Re: Monument Academy
Roundabout Report
Walker Road/Jane Lundeen Drive
El Paso County, CO
LSC #184820

Summary of Comments on LSC Responses to Roundabout Report Redline Comments.pdf

Re: Monument Academy
Roundabout Report
[1] Jane Lundeen Drive/Pinehurst Circle
El Paso County, CO
LSC #184820

Table 1
Pinehurst/Jane Lundeen Mini Roundabout
Date: 2-28-19
Monument Academy Charter School
El Paso County

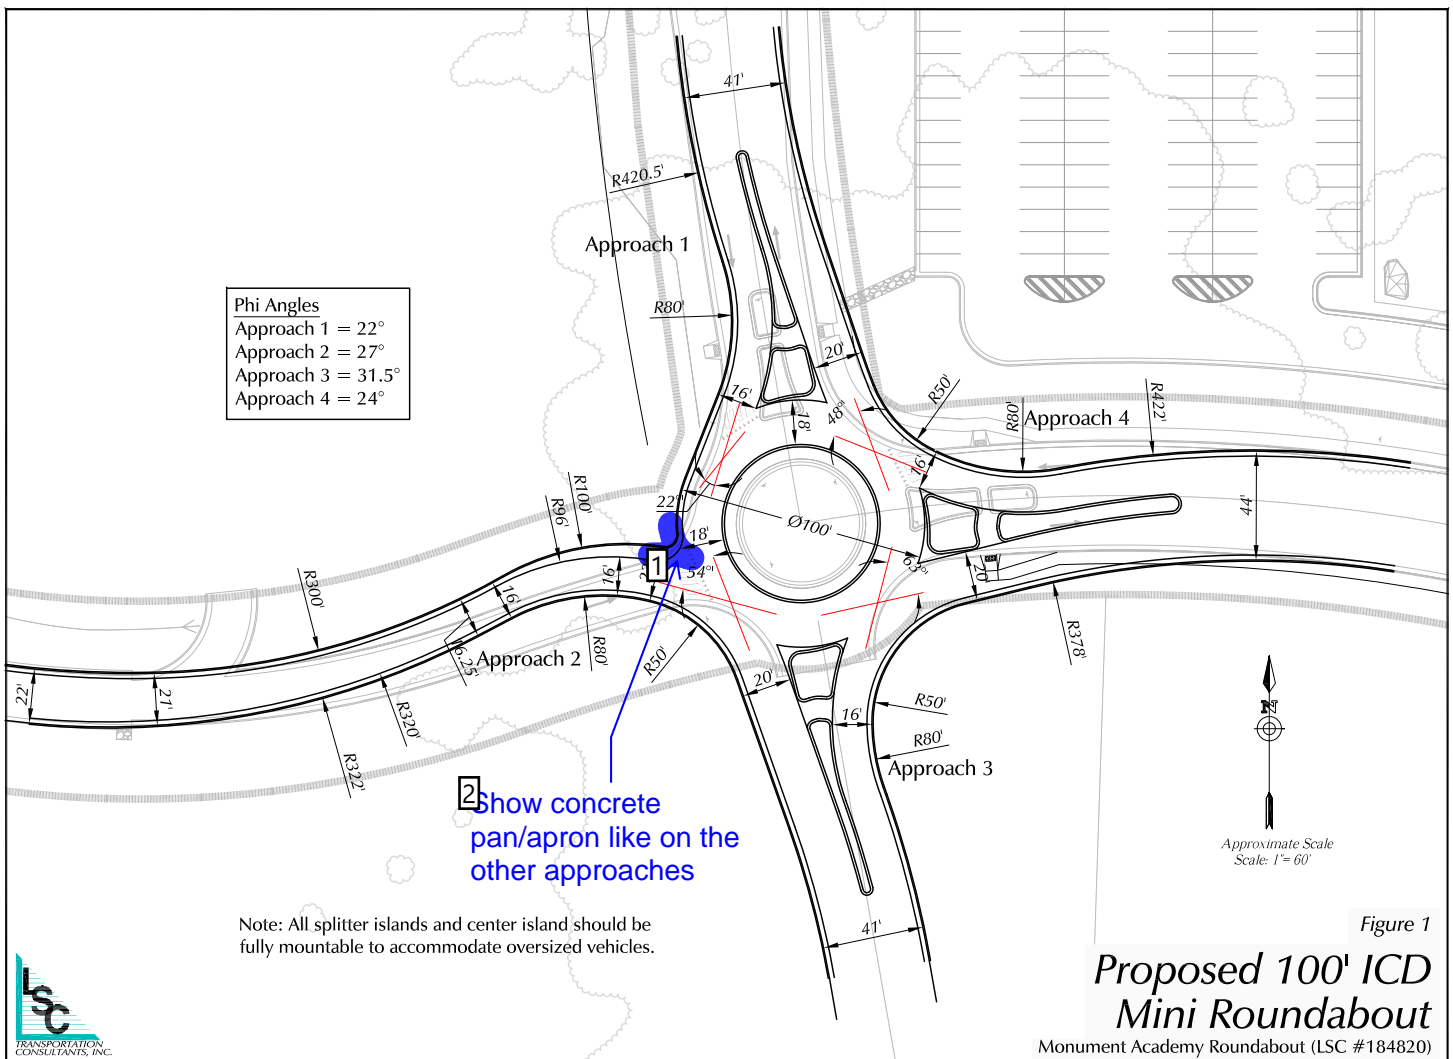
Ensure that PHI angles are correct per Method 1 (attached)

27, 37, 24?

LSC Response: The tables have been revised per the comment.

LSC Response: The tables have been revised per the comment.

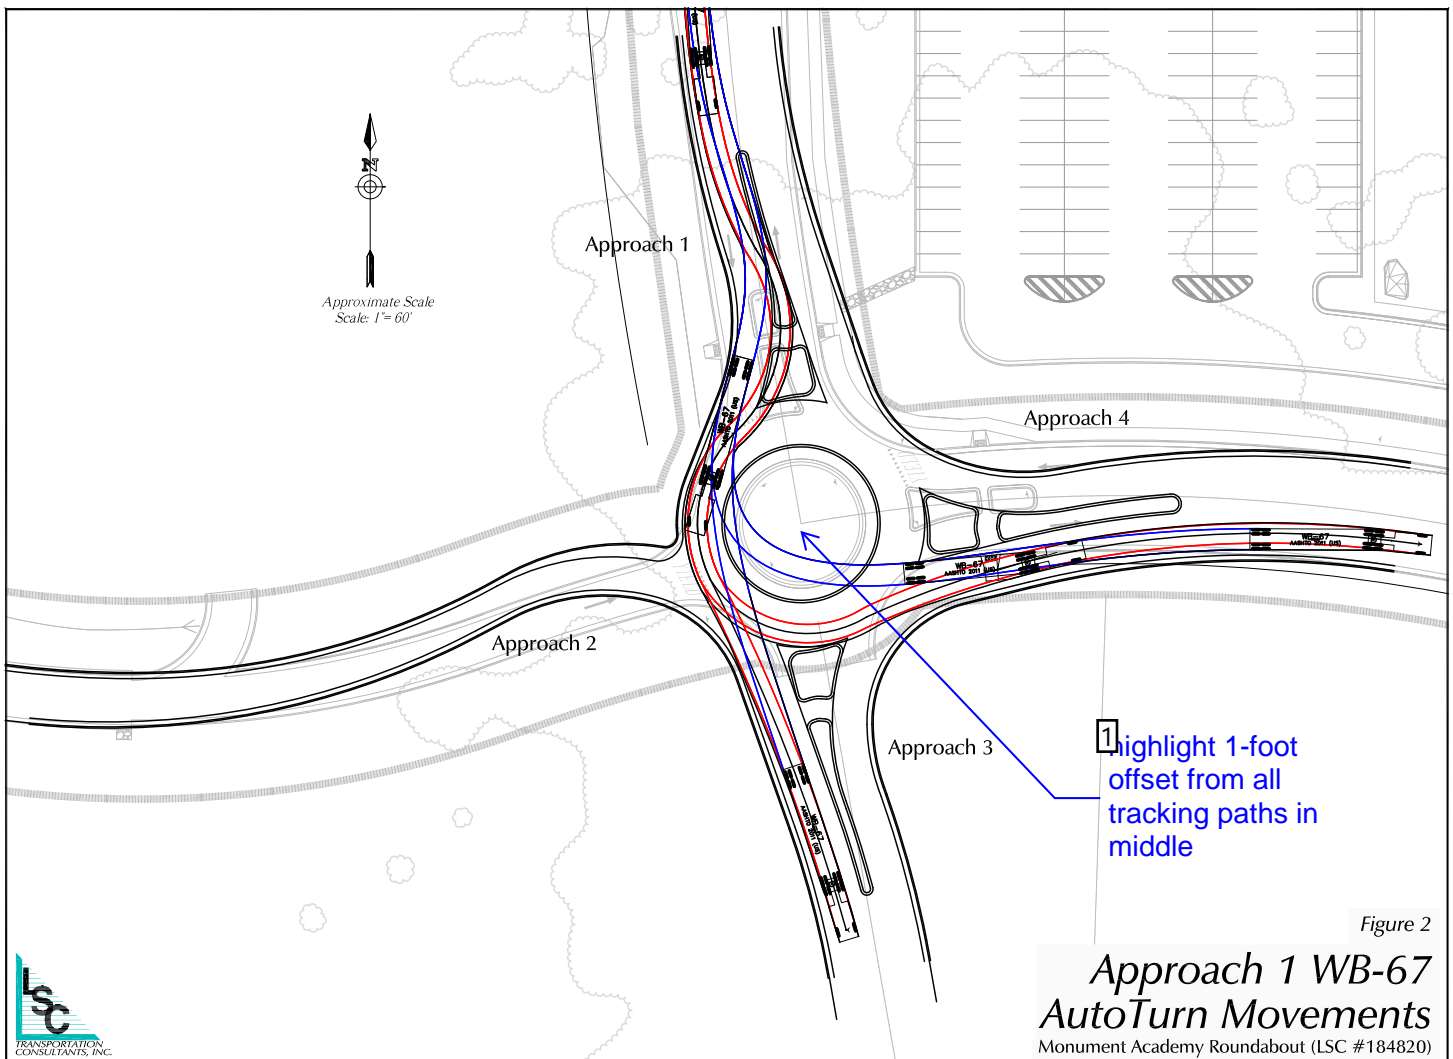
[Show concrete pan/apron like on the other approaches](#)

LSC Response: Modified as requested.

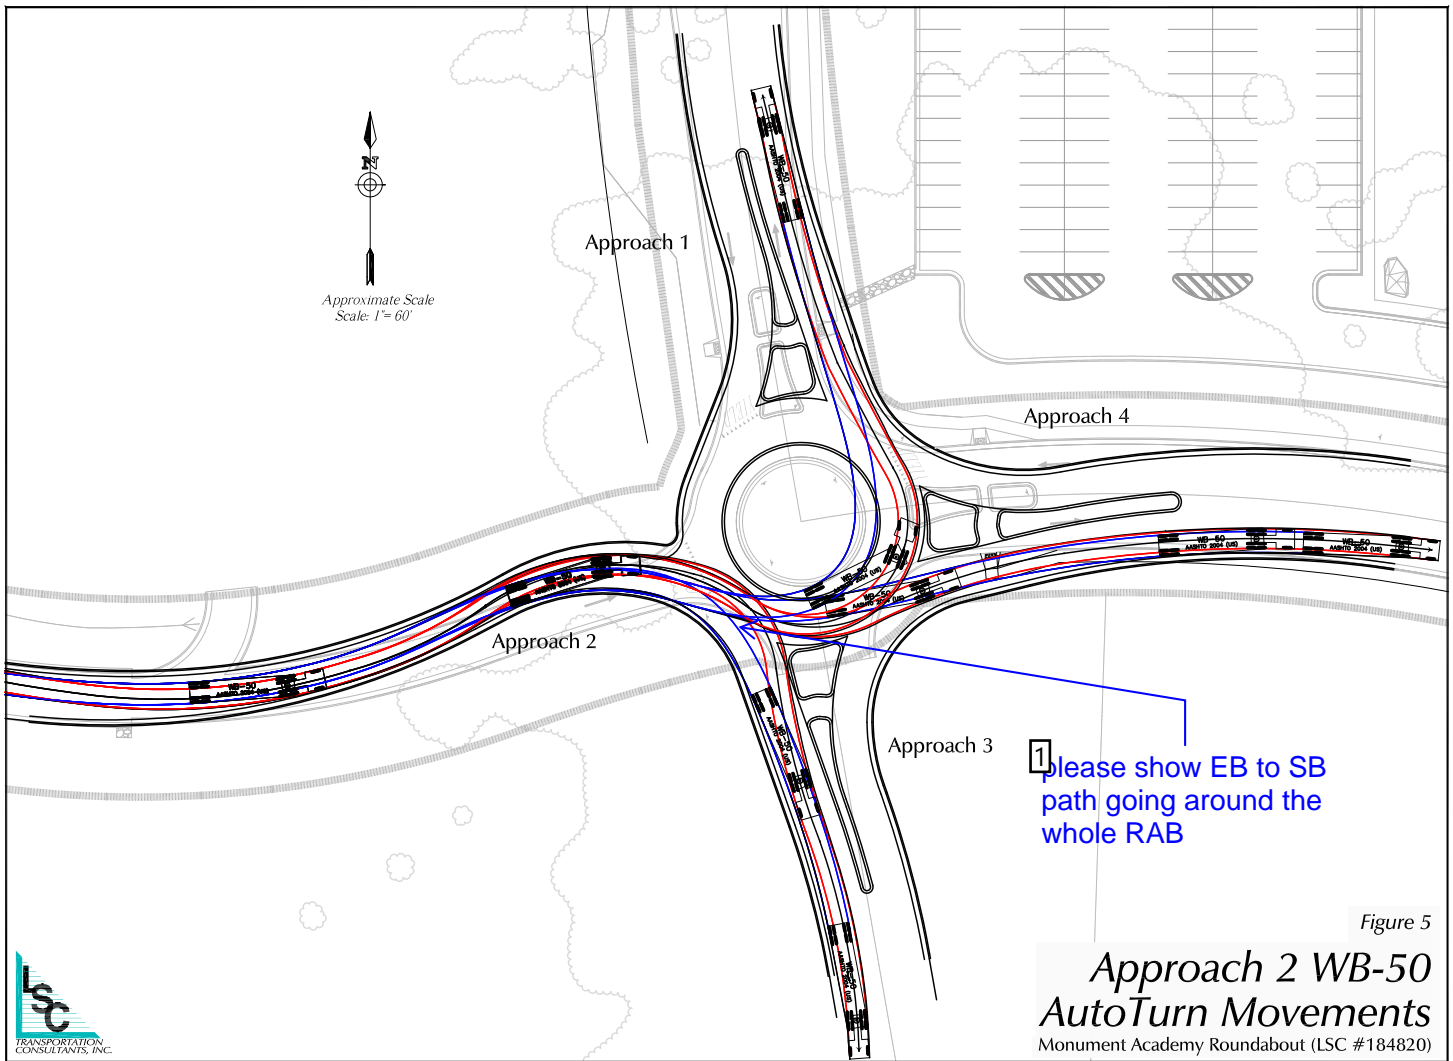
highlight 1-foot offset from all tracking paths in middle

LSC Response: Added as requested.

Figure 6

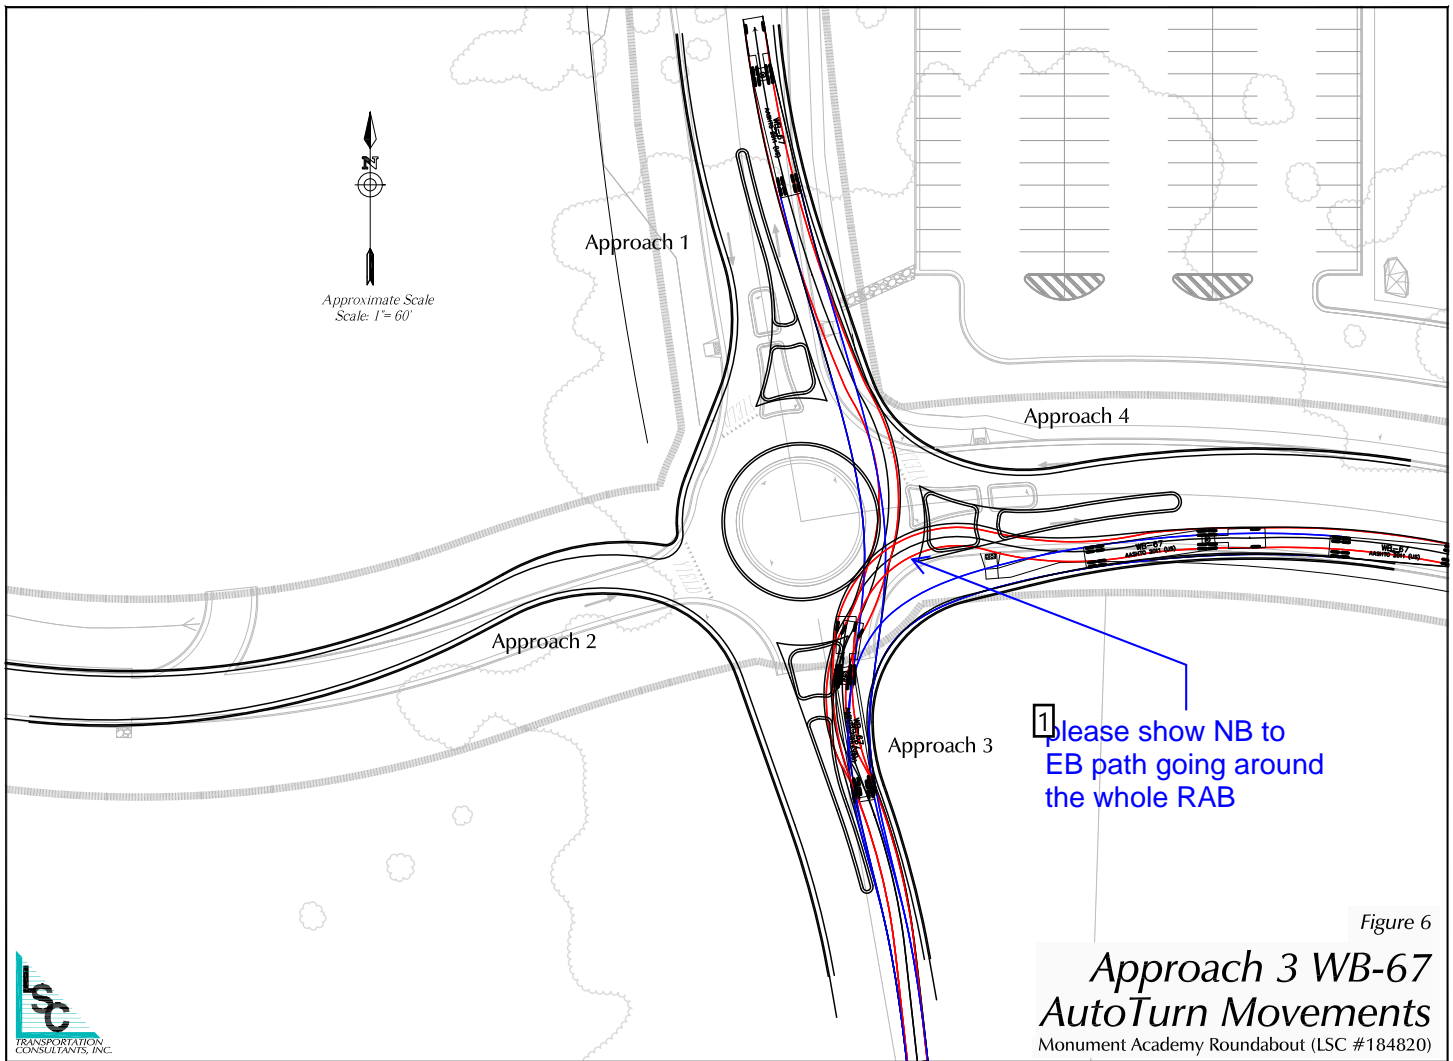
please show EB to SB path going around the whole RAB

LSC Response: The mini roundabout is too small for a large truck to do a u-turn or go 270 degrees around the center island – that is why the center and splitter islands have been designed to be mountable.

Figure 8

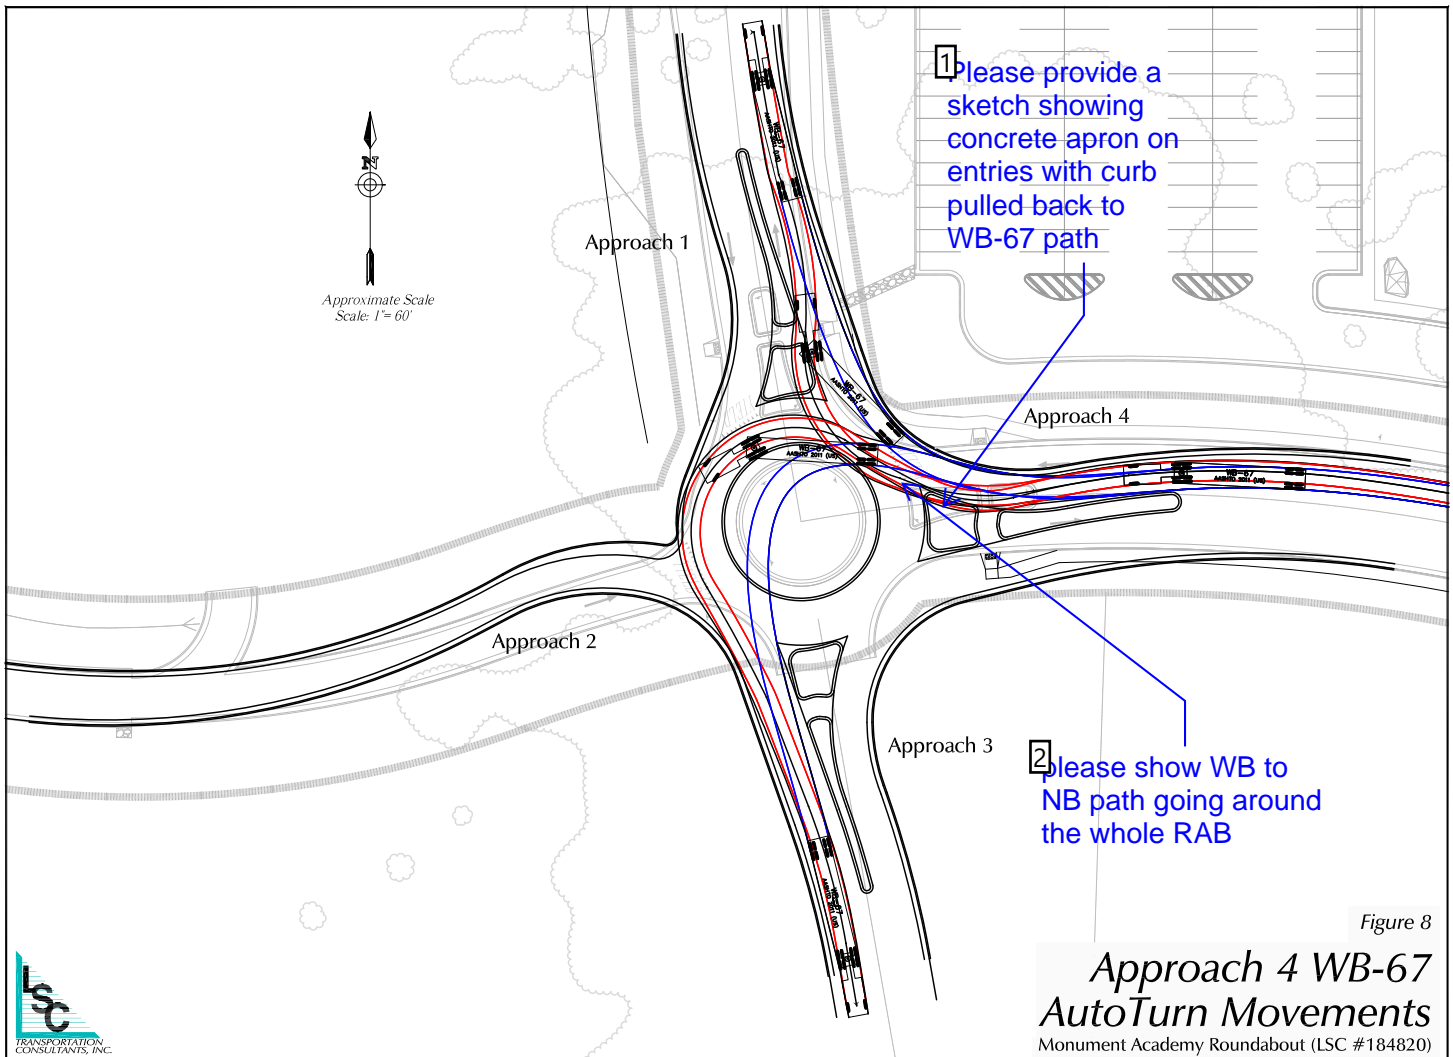
please show NB to EB path going around the whole RAB

LSC Response: The mini roundabout is too small for a large truck to do a u-turn or go 270 degrees around the center island – that is why the center and splitter islands have been designed to be mountable.

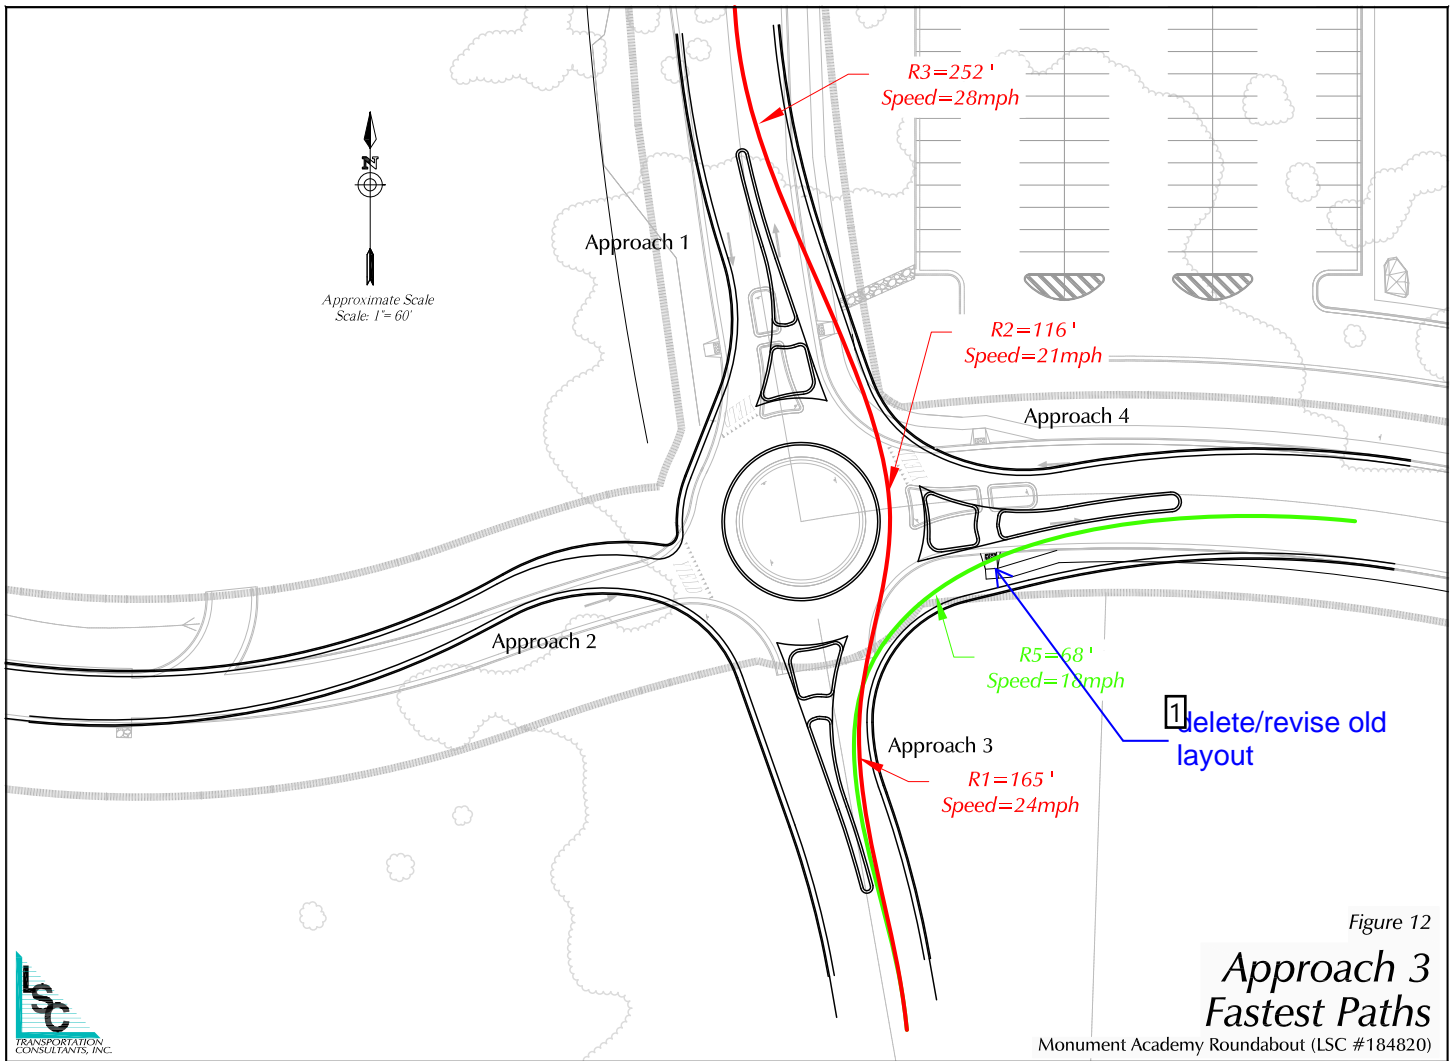
Please provide a sketch showing concrete apron on entries with curb pulled back to WB-67 path

please show WB to NB path going around the whole RAB

LSC Response: The curbs on the splitter islands has been pulled back, leaving room for concrete aprons on the entries (for the larger vehicles). The specific design of the aprons - color, pattern etc. is a design detail that will be finalized later. Note: The splitter islands and center island will be mountable.

LSC Response: The mini roundabout is too small for a large truck to do a u-turn or go 270 degrees around the center island – that is why the center and splitter islands have been designed to be mountable.
